SITE PLAN REVIEW DRAWINGS: FOR JONES DAIRY STORAGE FACILITY

1200 JONES DAIRY RD ROLESVILLE, NC 27587

SITE PLAN#: SDP-23-03 REZONING CASE #: MA-22-09 TEXT AMENDMENT CASE #: TA-22-02

INSET "A"

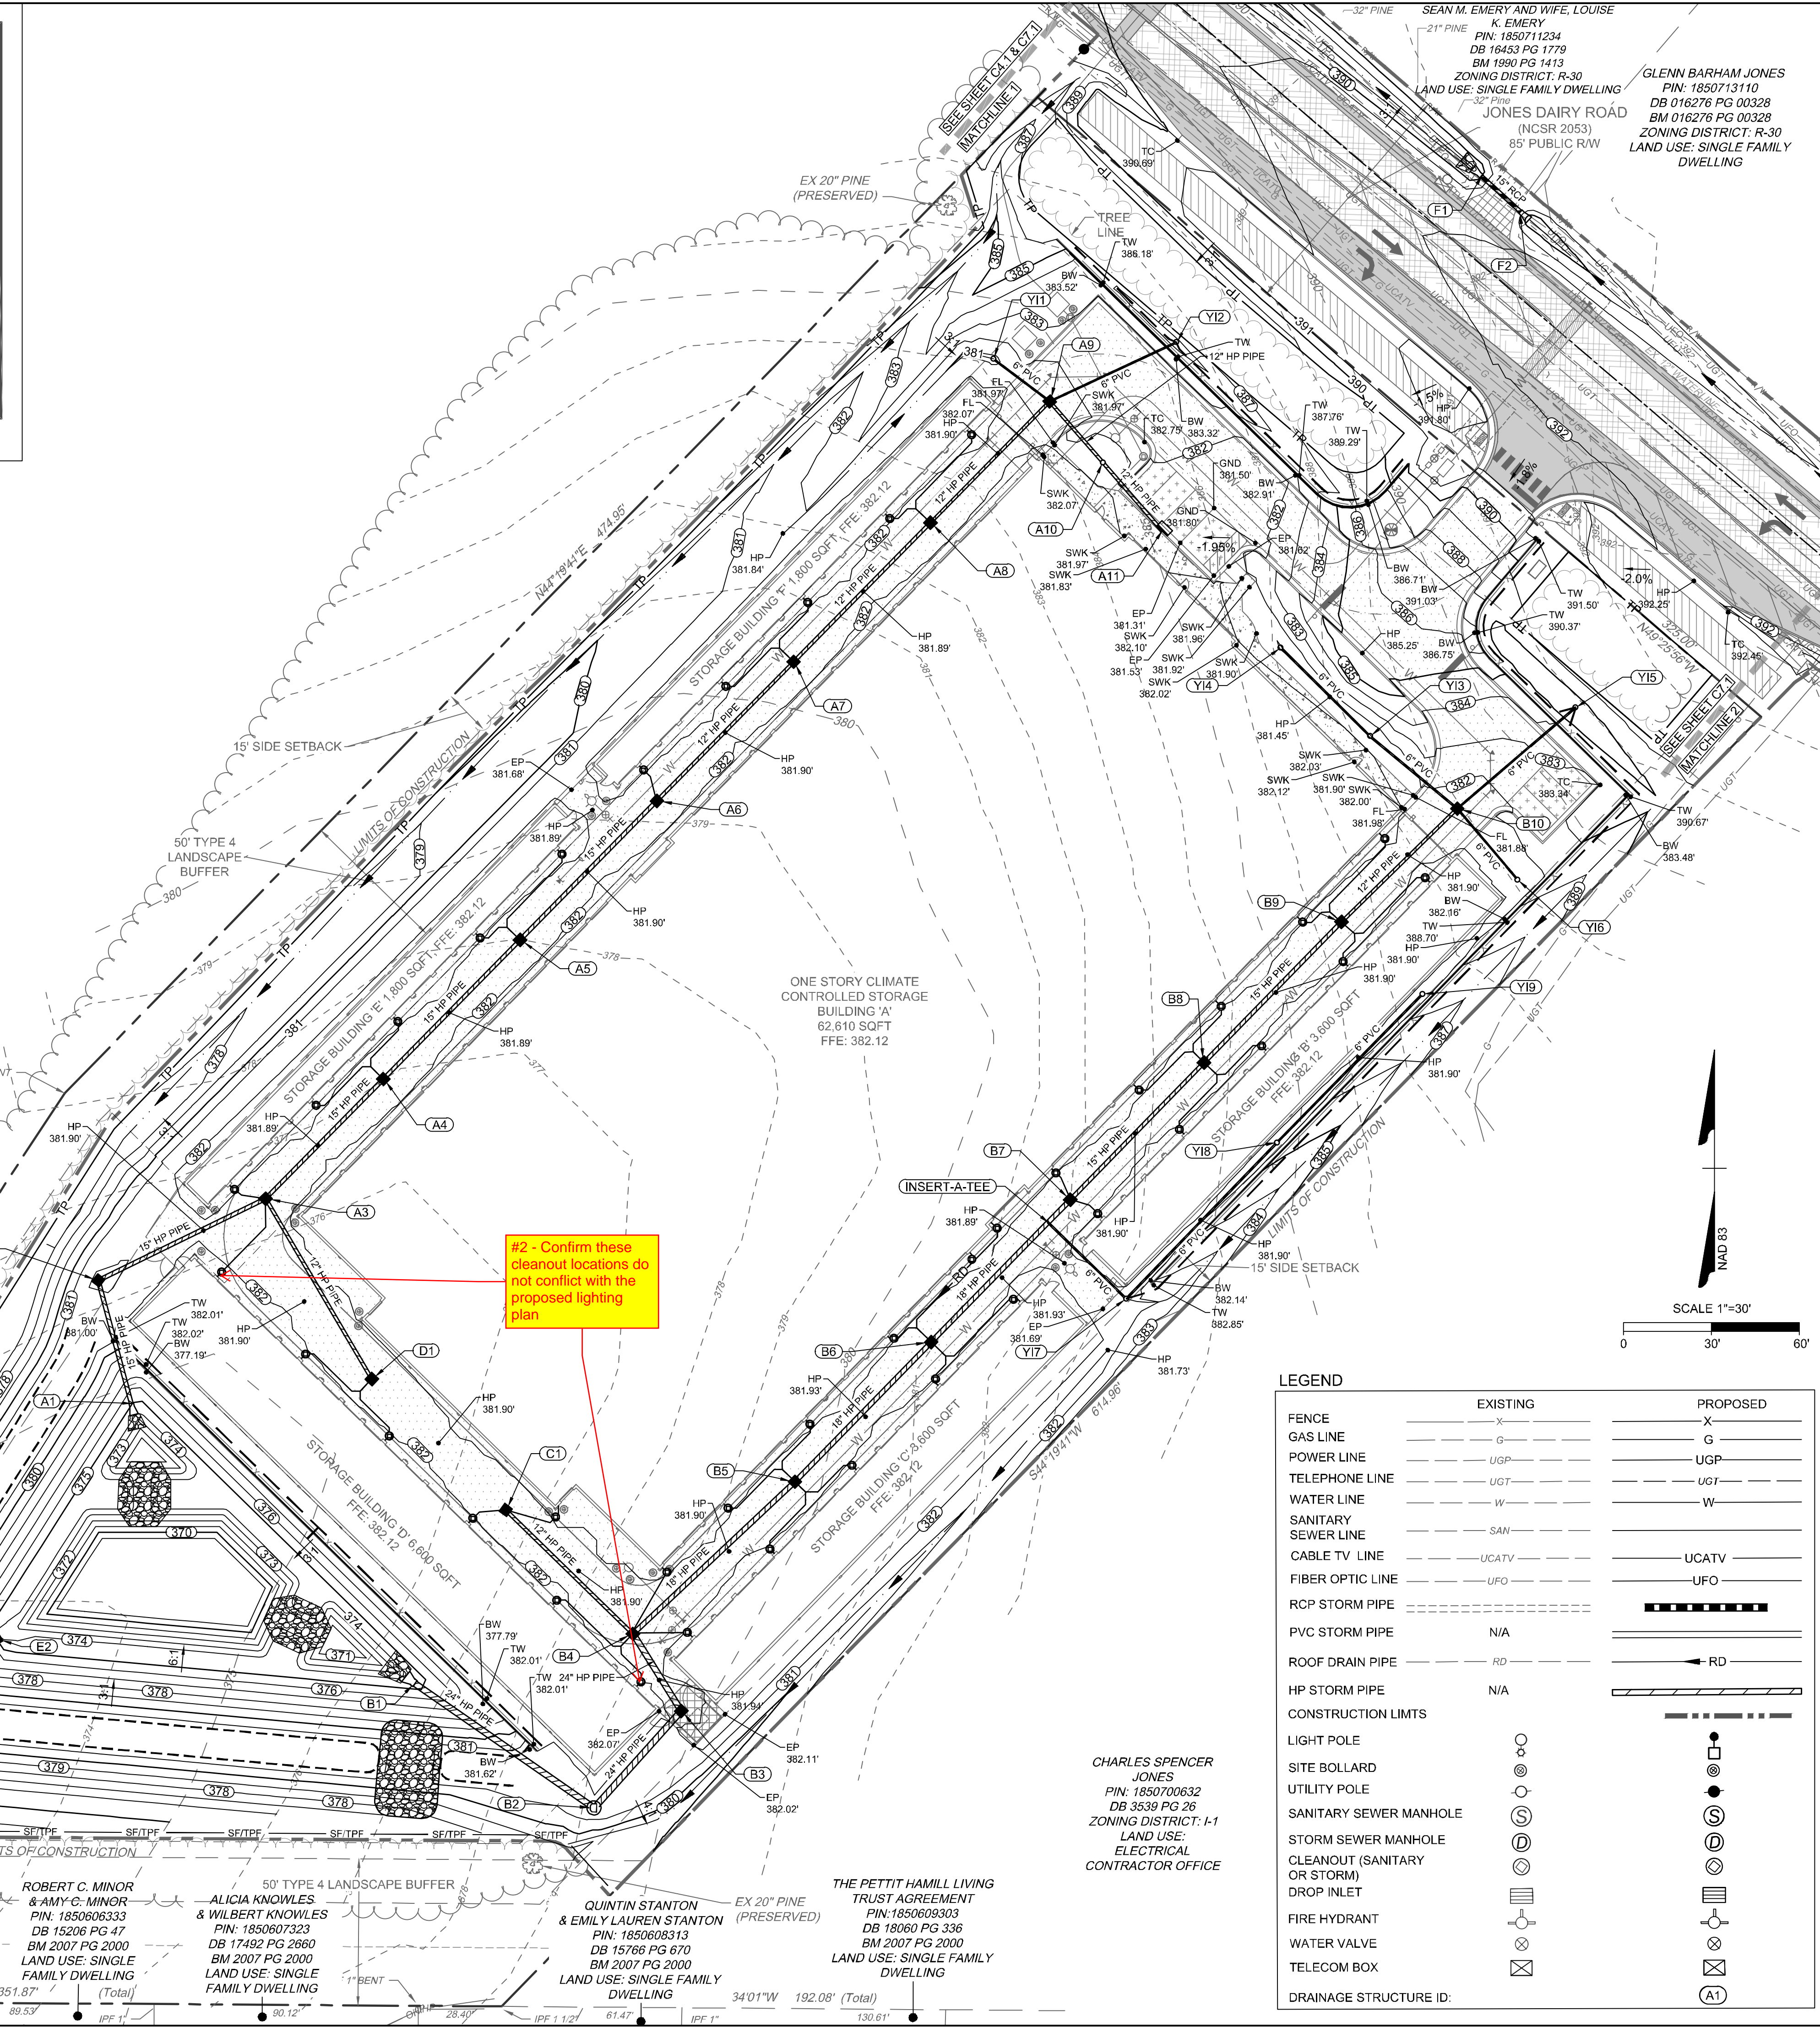
#2 - Confirm these cleanout locations do not conflict with the proposed lighting plan

JOB NO. 54832
 SHEET NO. C3.2

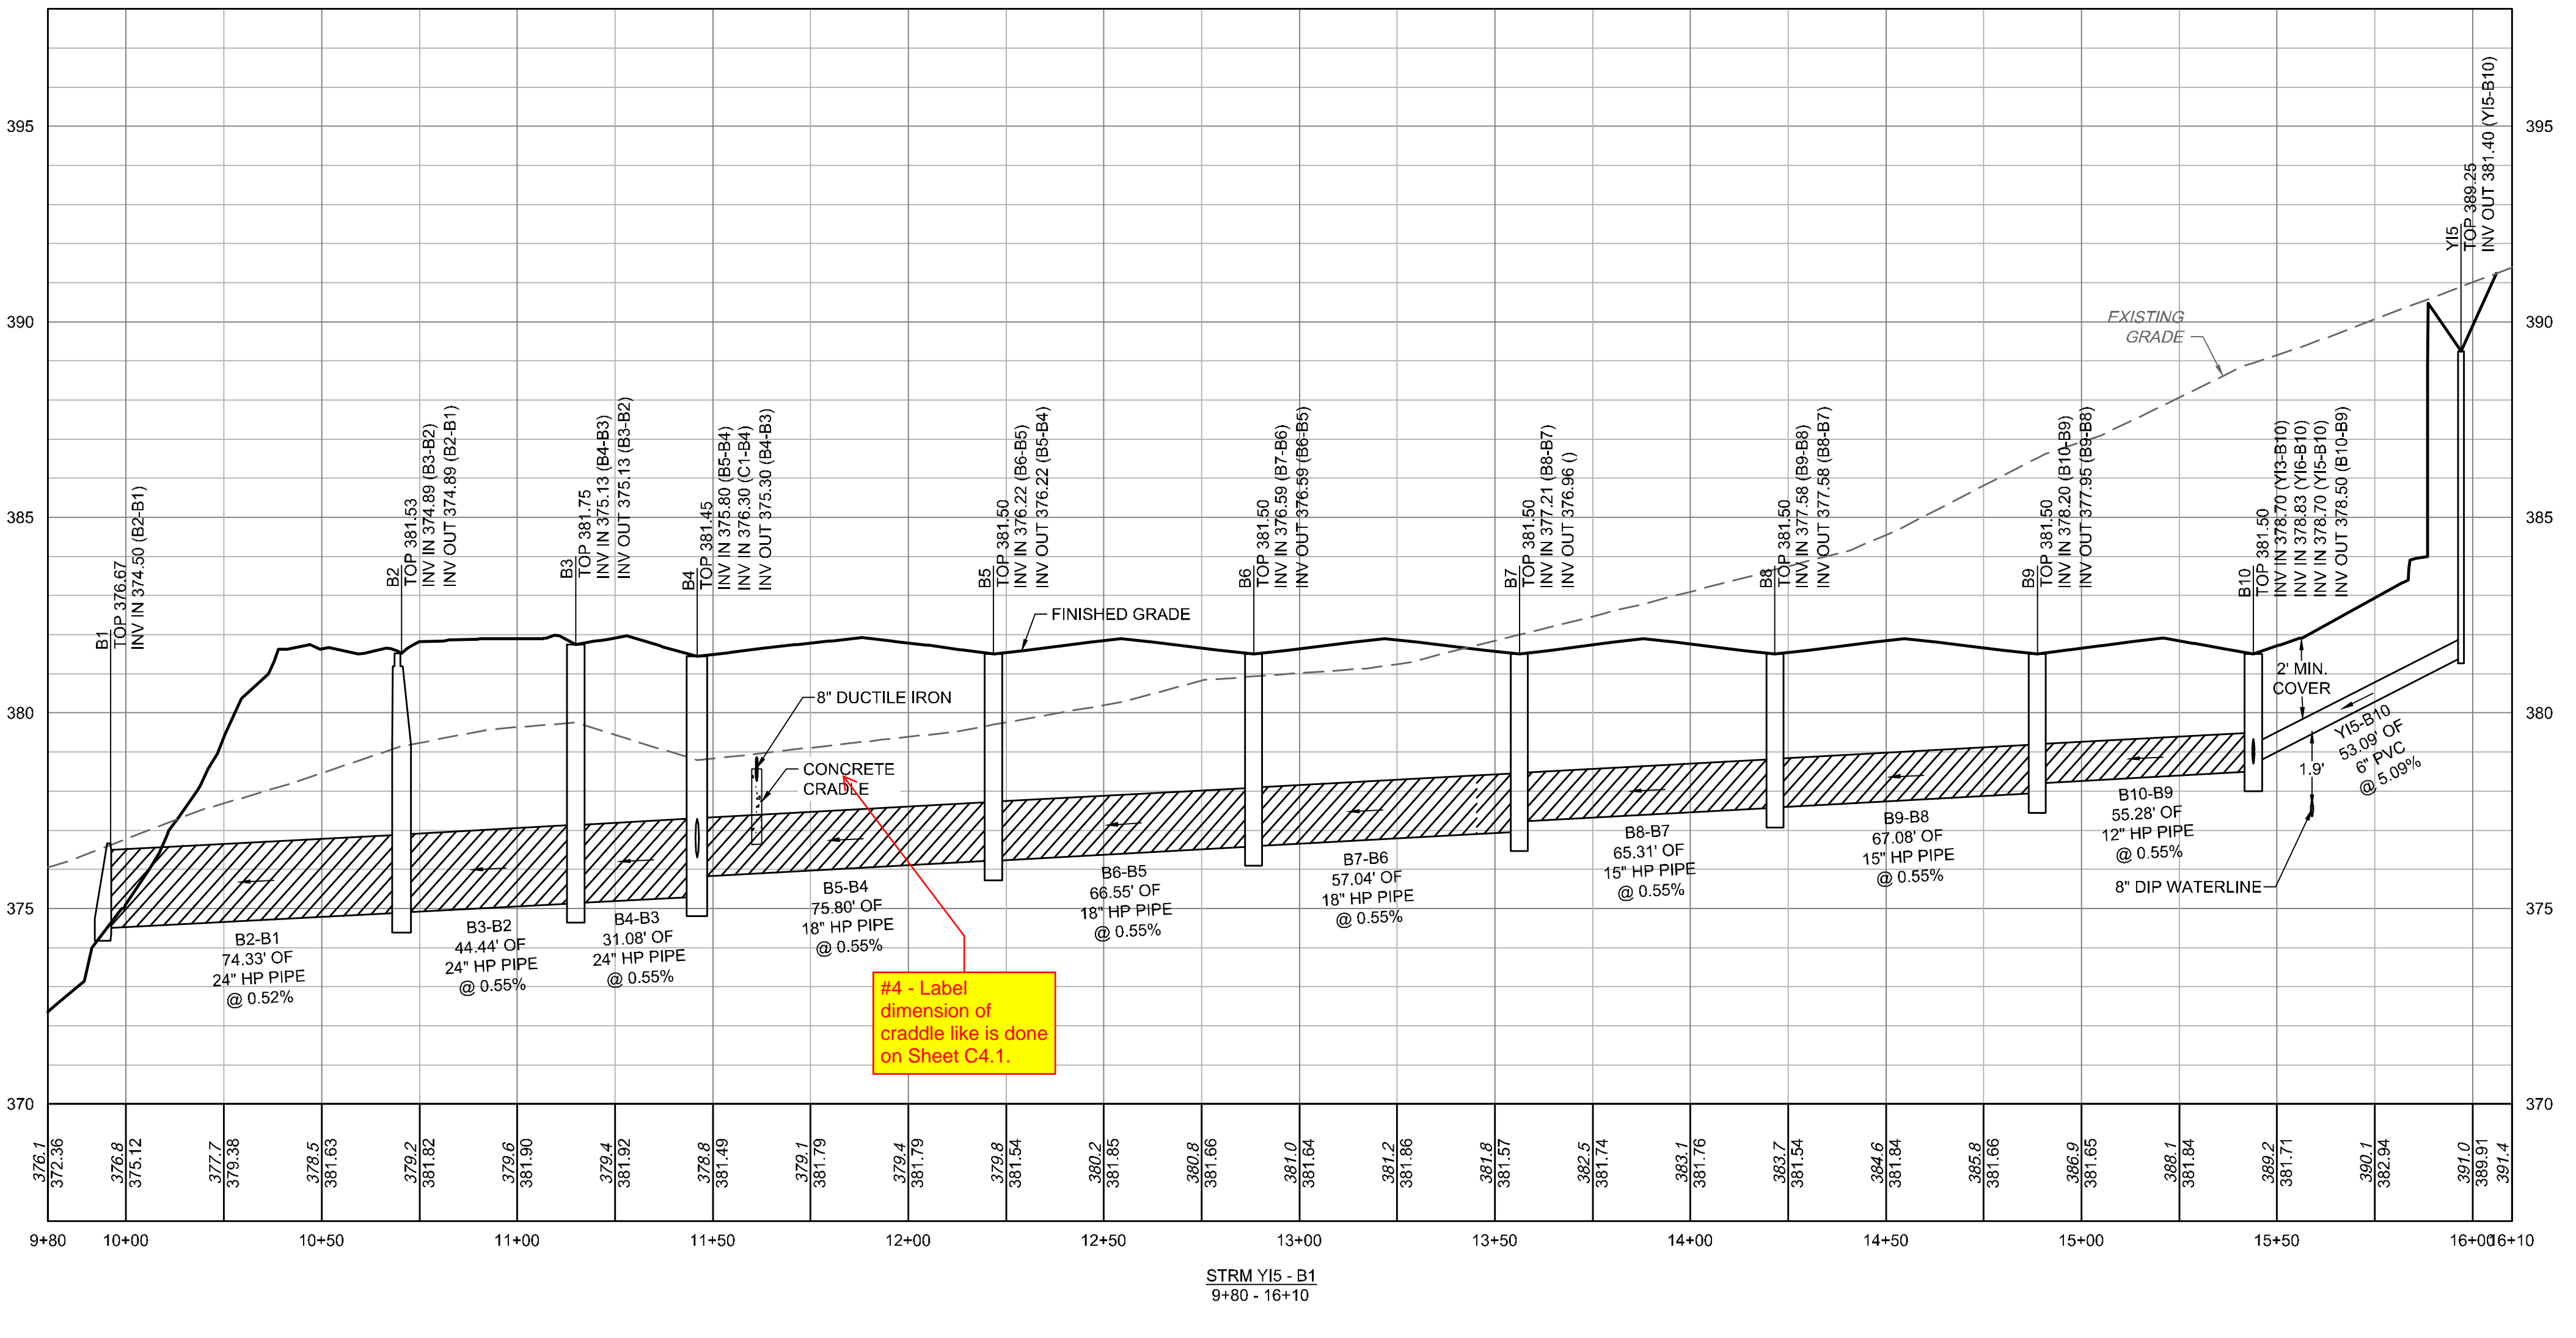
#3 - Doesn't have minimum cover, revise to meet requirement

#4 - Label dimension of cradle like is done on Sheet C4.1.
